CARR & J. E. GREINER CO.—ARCHITECT-ENGINEERS
 DURHAM, N. C. BALTIMORE, MD.
CAMP LEJEUNE — NEW RIVER, N. C.
 BUREAU OF YARDS AND DOCKS — U. S. NAVY

SWIMMING POOLS
DRAINAGE LAYOUTS
 DIVISION TRAINING AREA
 MONTFORD POINT AREA

DRAWN BY <u>Burghardt</u>		CARR & J. E. GREINER CO.—ARCHITECT-ENGINEERS DURHAM, N. C. BALTIMORE, MD.	
CHECKED BY <u>Scheller</u>		CAMP LEJEUNE — NEW RIVER, N. C. BUREAU OF YARDS AND DOCKS — U. S. NAVY	
IN CHARGE <u>Taylor</u>		SWIMMING POOLS SEWER AND WATER PLAN	
DATE <u>Oct. 29, 1943</u>		REGIMENTAL AREA No. 2	
SCALE <u>As Noted</u>		Y. & D. DRAWING NO.	
NO. <u>11905</u>		287873	
ARCHITECT-ENGINEERS SPECIFICATION		APPROVED <u>27 Oct 1943</u>	
REV. BY DATE		BY <u>[Signature]</u> OFFICER IN CHARGE	
BRIEF		SHEET	
O. I. C.		PROJ. NO. P-1510-12	
NO. 11905		DWG. NO. 1518

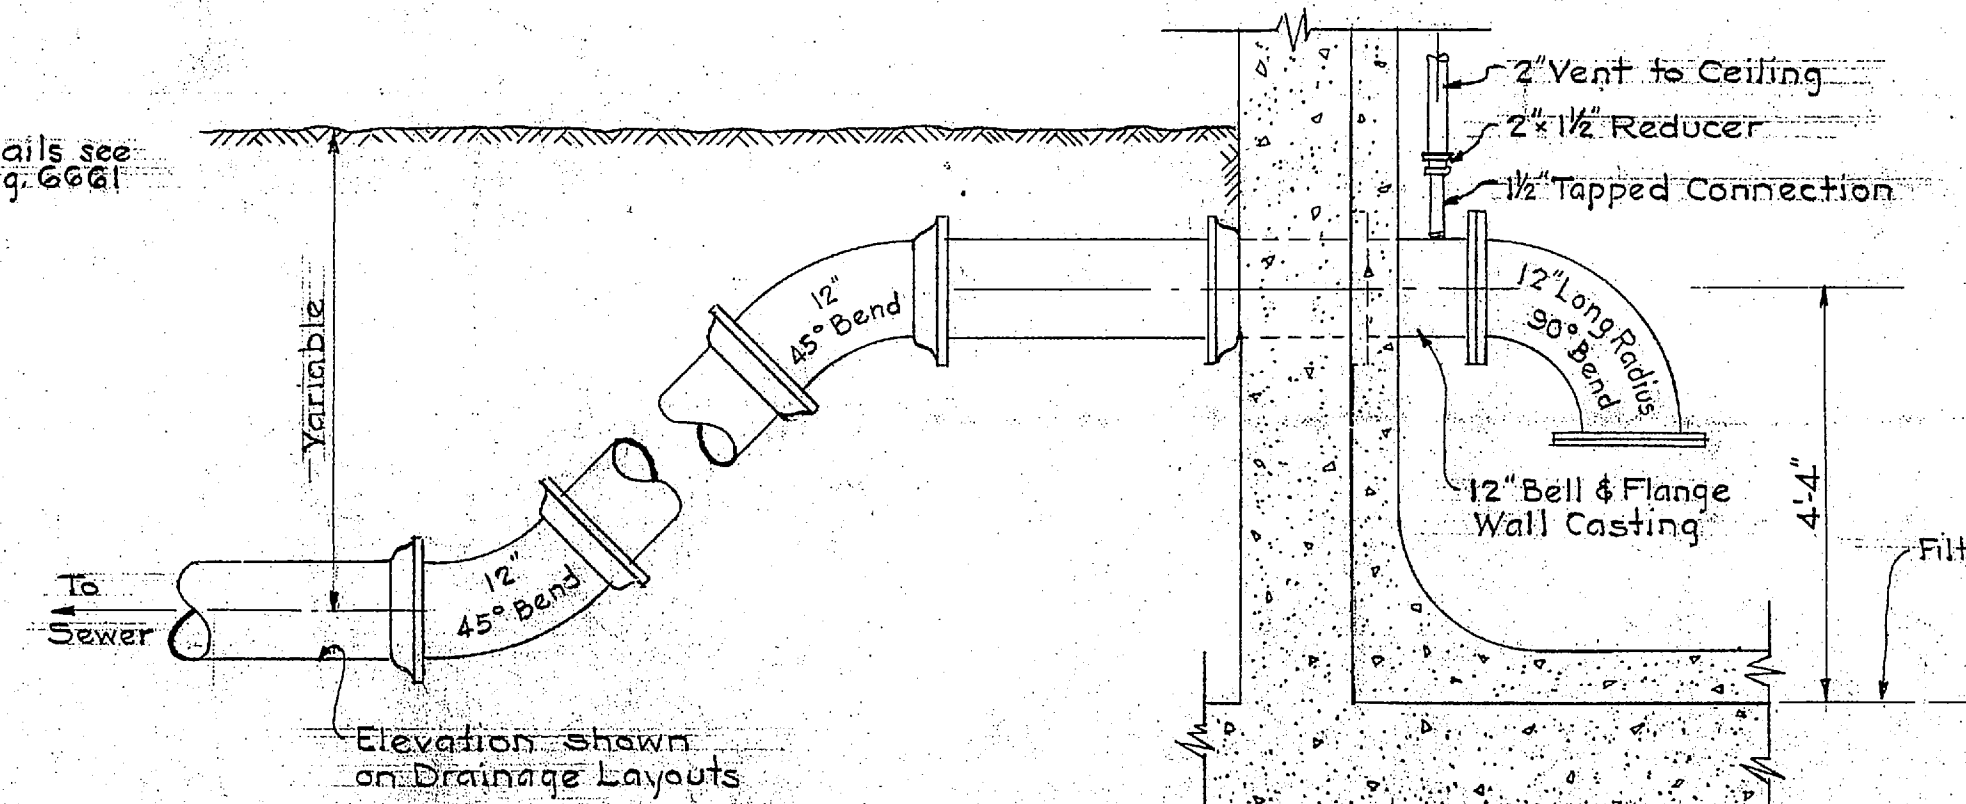
REVISION	DATE	BRIEF	IN CHARGE	BY
PWO B	1-7-44	1/4 sewer changed to 5, See Rev. A Dwg 287895 Pipe changed from T.C. to S.P.	Edw Sutherland	Sutherland
A	12-6-43	REVISED DRAINAGE LAYOUTS TO REMOVE WASH WATER, SCUM GUTTERS (EXCEPT M.P.) & FLOOR DRAINS FROM THE SEWER AS DIRECTED	Edw Sutherland	ALBERT

Rev.	By	Date	Brief	PWO
G	Sutherland	12 Apr 44	Drain added for new areaway	Edw

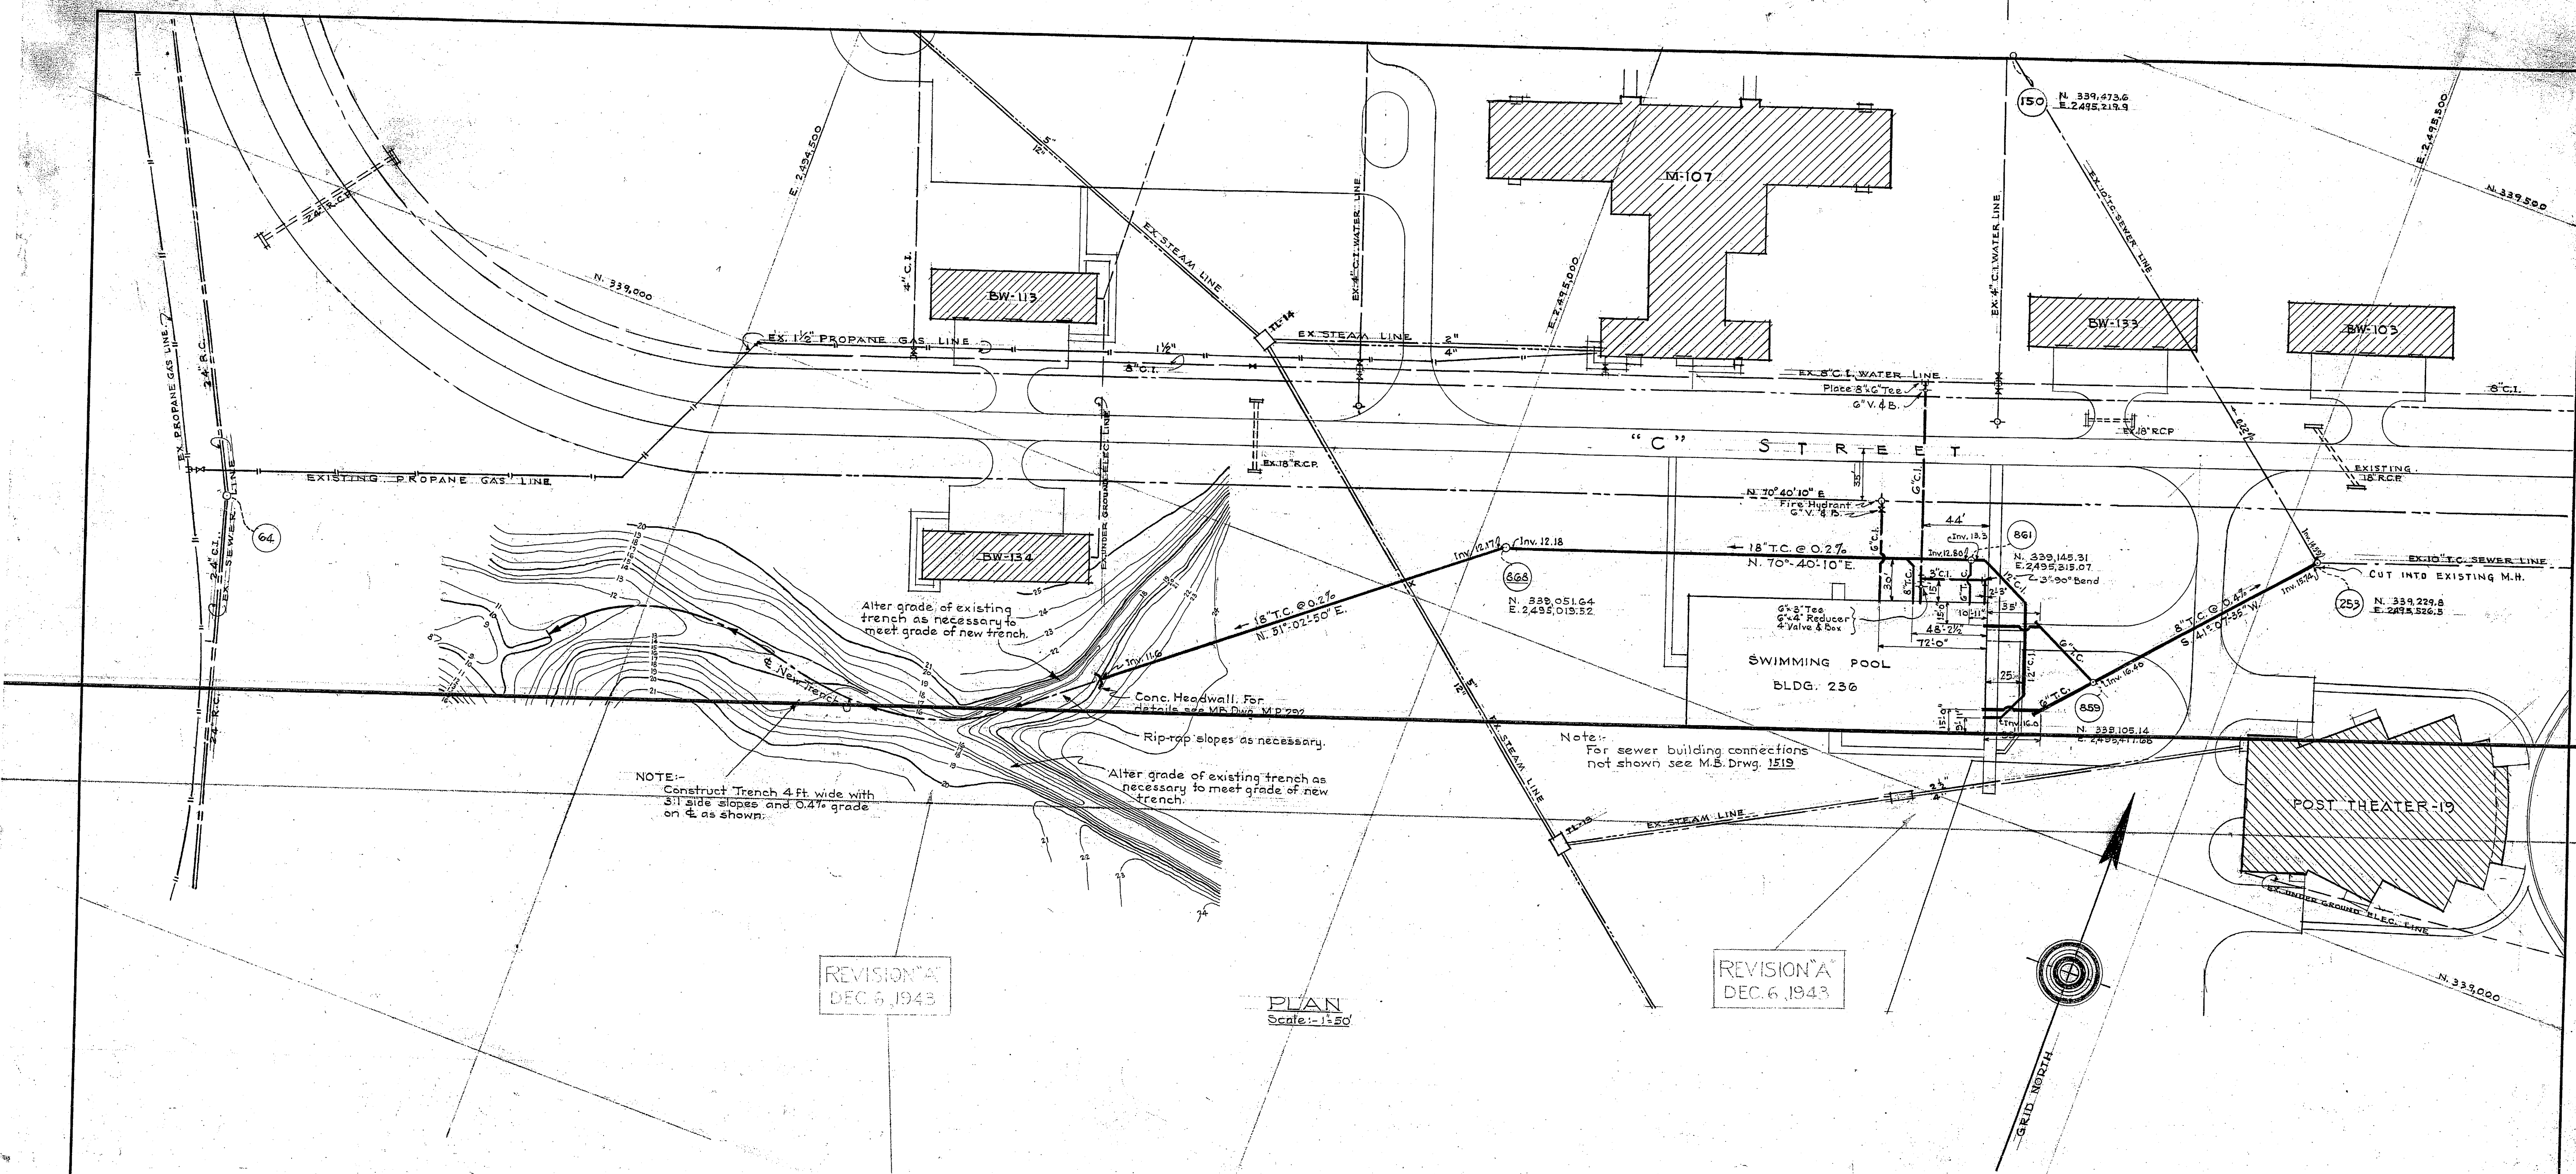
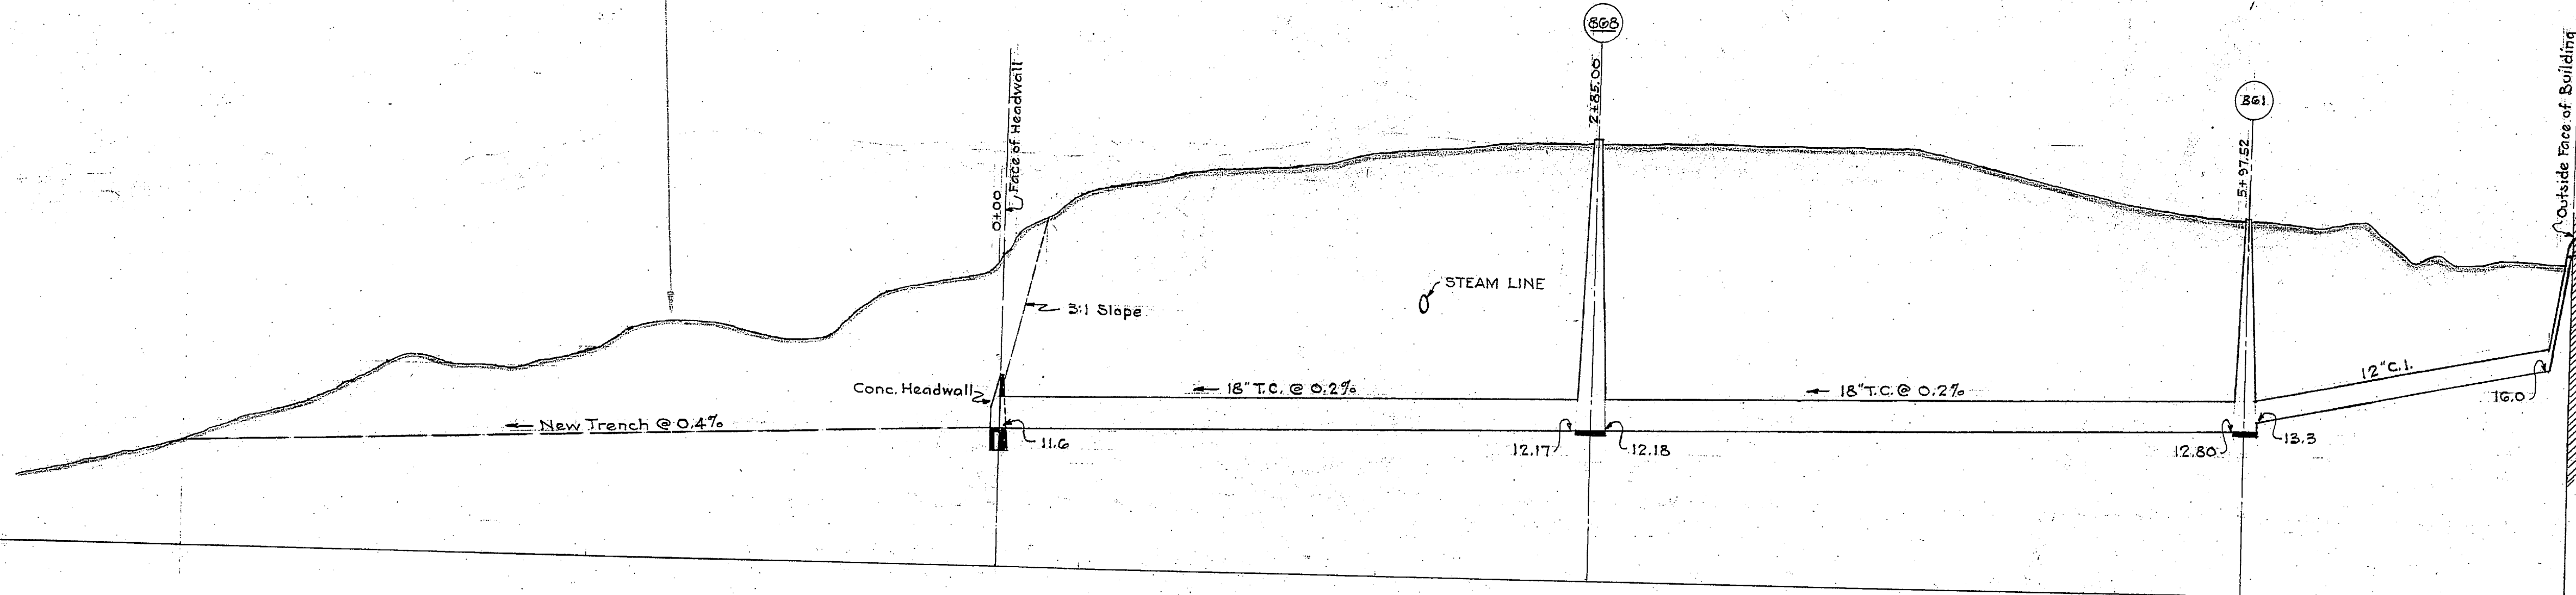
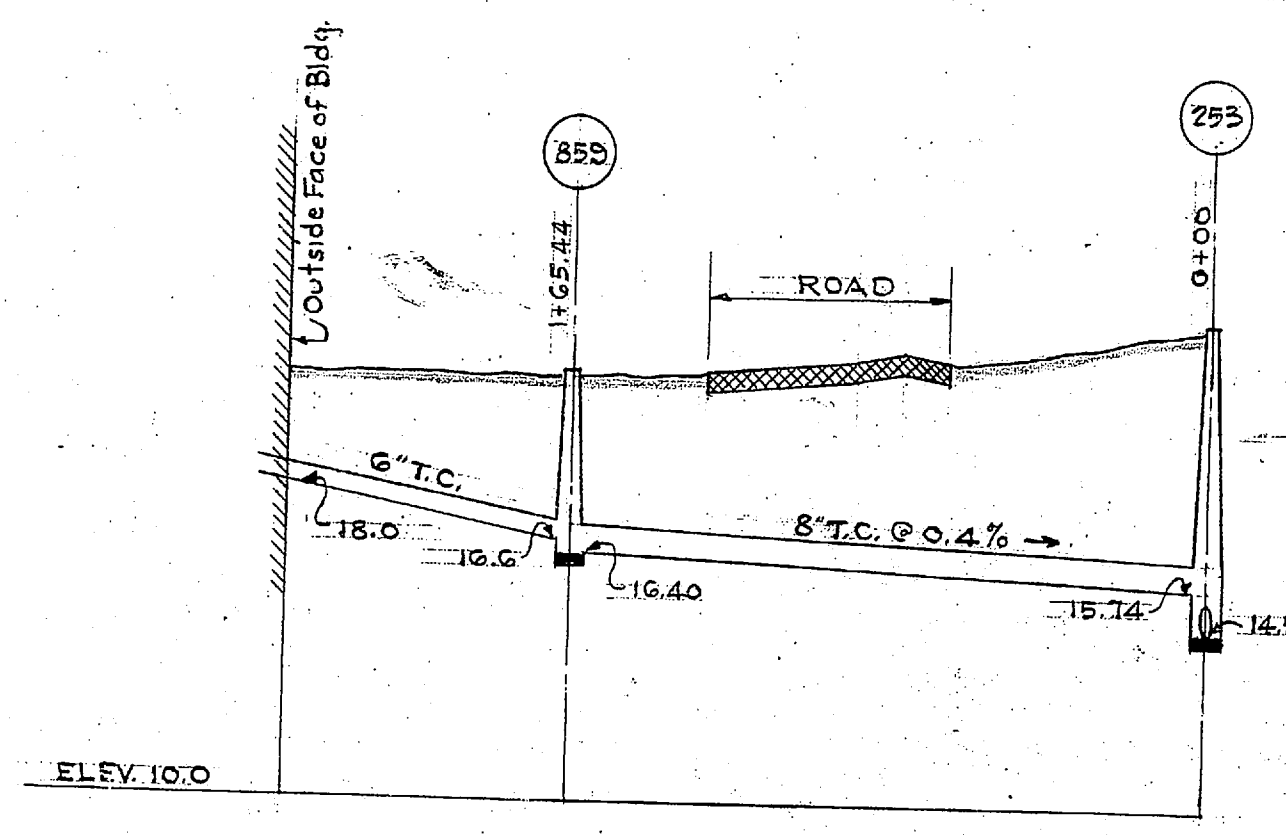
A	BURGHARDT	12-6-43	ADDED 8" SEWER & 6" CONN. FROM M.N. 253 TO BLDG. WATER, FLOOD & SCUM QUITER DRAINS FROM SEWER AS DIRECTED. ADDED F.H. CONN. TO PDDL.
---	-----------	---------	--
